Memorandum

| Subject | Transmission Gully - Post Construction Inspections Summary | | |
| From | Shivam Jakhu | | |
| File/Ref No. | | Date | 27-Feb-2023 |

Figure 4 Image of noise wall N4 from site inspection

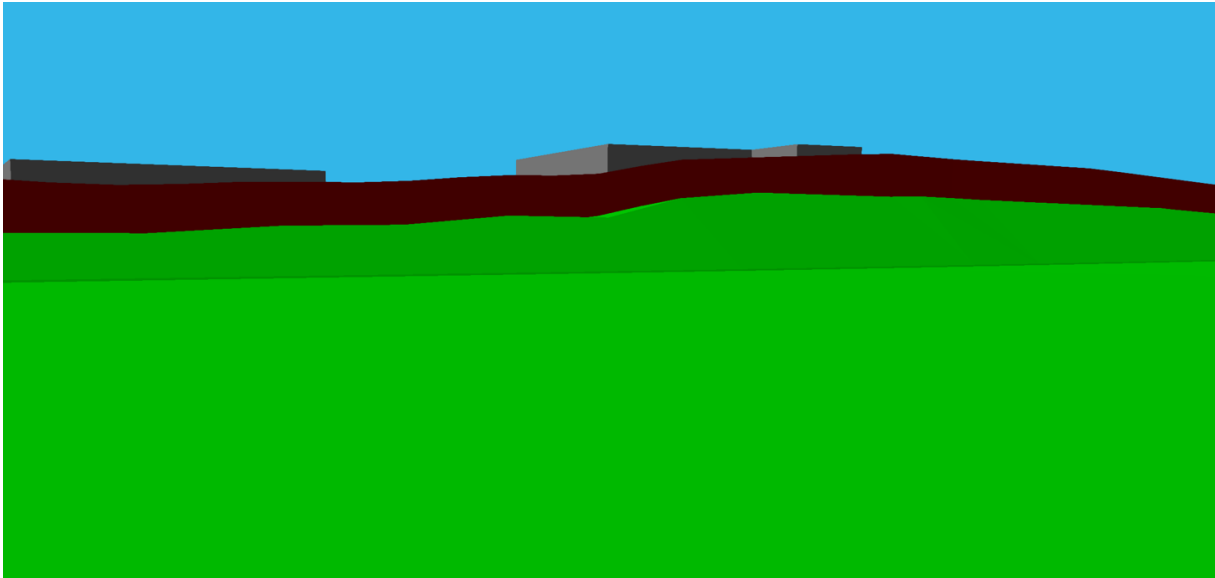
A visual comparison was made of the noise wall compared to the noise model and was found to be generally consistent as seen when comparing Figure 3 and Figure 4.

Figure 8 Typical picture of noise wall N2

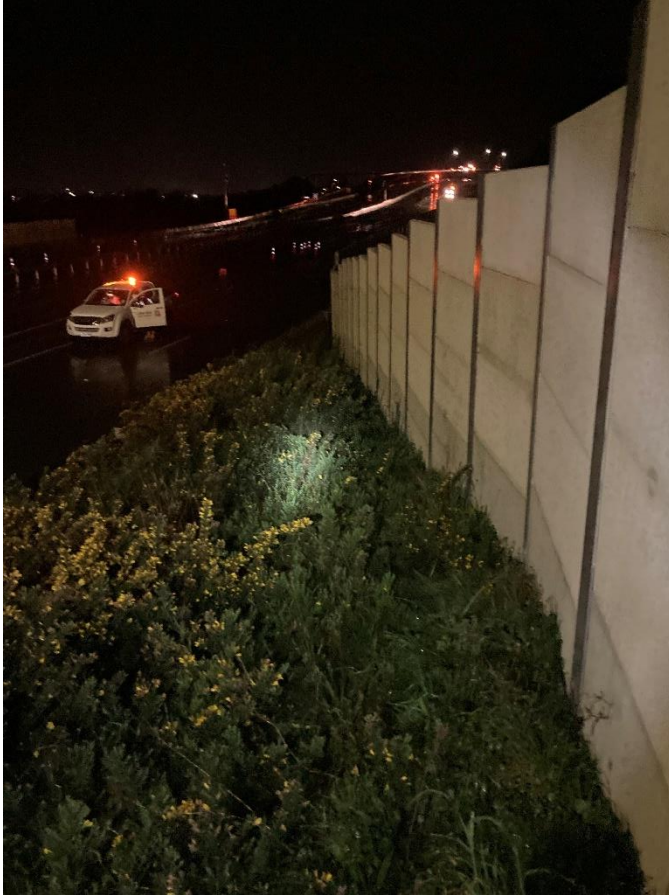
This noise wall was constructed along mostly steep ground, and due to safety concerns at the time of the inspection, the noise wall was not physically measured along approximately half of its length. Gaps were found along some parts of this noise wall during the inspection and were reported to CPB HEB JV, which were later rectified by the contractor.

The height of the noise wall was recorded along its length and was generally found to be consistent with the noise model; the height of the noise wall was recorded to be below the design height for a total length of 3m out of the 25m that was inspected. The as-built geometry of the noise wall was included in the post-completion noise model, and noise predictions at nearby PPFs were found to be consistent with the predictions undertaken for the Detailed Design phase.
